PLAN-009778

**Proposal: Single storey rear extension.**

**Site: 35 Park Lane, Cowplain, Waterloooville, PO8 8AG.**

**APP/15/00450**

Southern Water MapGuide Browser

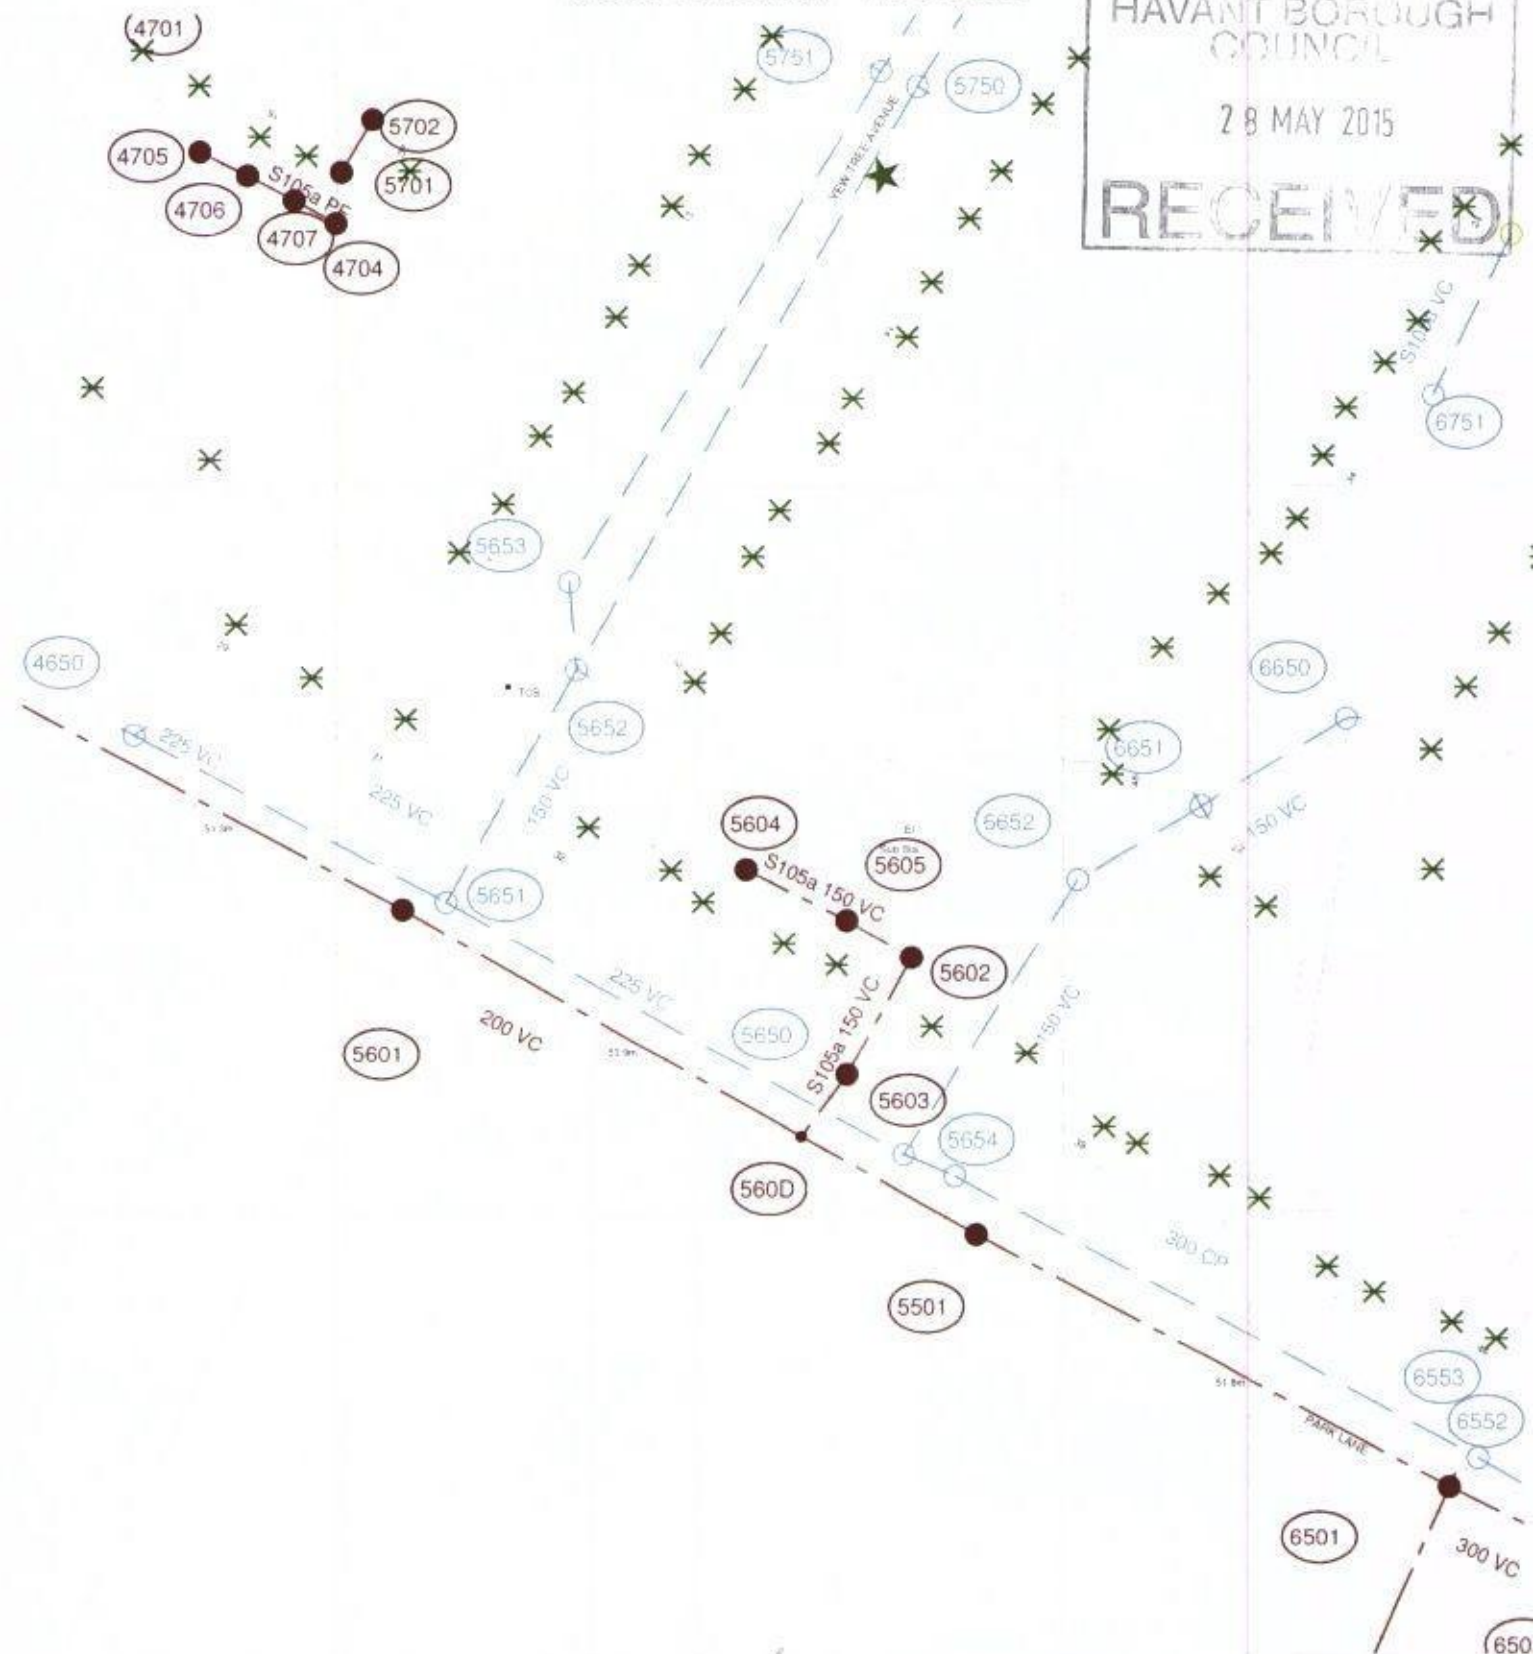
Please find attached a plan of the sewer records showing the approximate position of foul sewer crossing the site. The exact position of the foul sewers must be determined on site by the applicant before the layout of the proposed development is finalised.

1. The 150 mm diameter sewer requires a clearance of 3 metres either side of the sewer to protect it from construction works and allow for future access for maintenance.
2. No development or new tree planting should be located within 3 metres either side of the centreline of the foul sewer
3. No new soakaways should be located within 5 metres of a public sewer.
4. All other existing infrastructure should be protected during the course of construction works.

Due to changes in legislation that came in to force on 1st October 2011 regarding the future ownership of sewers it is possible that a sewer now deemed to be public could be crossing the above property. Therefore, should any sewer be found during construction works, an investigation of the sewer will be required to ascertain its condition, the number of properties served, and potential means of access before any further works commence on site.

It might be possible to divert the foul sewer, so long as this would result in no unacceptable loss of hydraulic capacity, and the work was carried out at the developer's expense to the satisfaction of Southern Water under the relevant statutory provisions.

Alternatively, the applicant may wish to amend the site layout, or combine a diversion with amendment of the site layout. If the applicant would prefer to advance these options, items (1) – (4) above also apply.
